**RE: PROPOSED GATE, GATEHOUSE, WASHROOMS, AND
FENCING OF BANISSA AIRSTRIP – MANDERA COUNTY**

TENDER NO. KAA/OT/BANISSA/0076/2023-2024

ADDENDUM NO. 4

RAZOR WIRE FENCE DETAILS

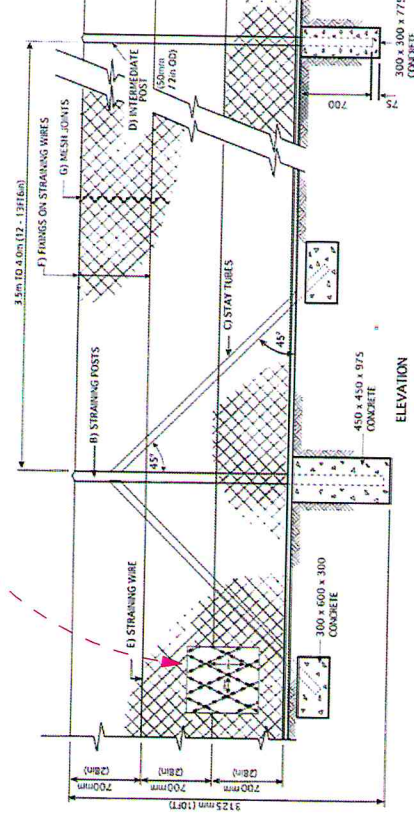
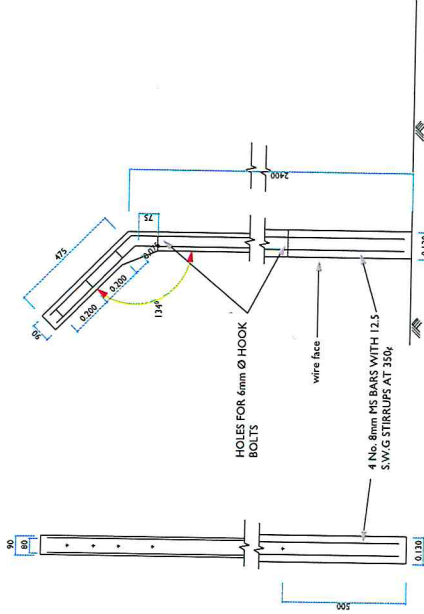
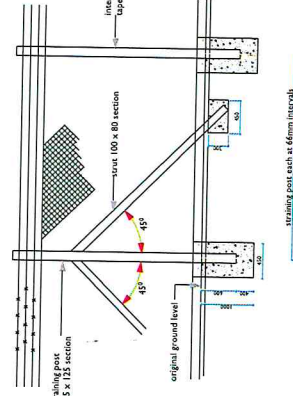
3.	There is some discrepancy on Chain link fencing description on the specification (page 87) and the drawing.	The clarifications for the fence type is as follows: - i. The description of works in under item 5 "E" iv on page 73 of the tender document should read "High Density Galvanized Welded Razor Fence" instead of "Chain-link Fence.

ii. The description of the fence type under Fencing Works Bill item No. 6, P on page No. 139 clearly reads "Supply and Install High-Density Galvanized Welded Razor Mesh with Diamond Apertures", this also corresponds to the drawing No. A (01) 02 with the title "Razor Wire Fence Details" as attached.
4.	The Title on BOQ pages 74, 75,76,77, 78, 80, 81, 82, 83, 84, 85, 86, 90, 91, 92, 94, 95, 96, 97, 98, 99, 100, 101, 102, 104, 105, 106, 123, 124 and 125 reading "PROPOSED CONSTRUCTION OF GATE HOUSE, WASHROOMS AND CHAINKINK FENCE AT BANISA AIRSTRIP"	Bidders are informed that they need to replace the title to read "PROPOSED GATE, GATEHOUSE, WASHROOMS, AND FENCING AT BANISSA AIRSTRIP"
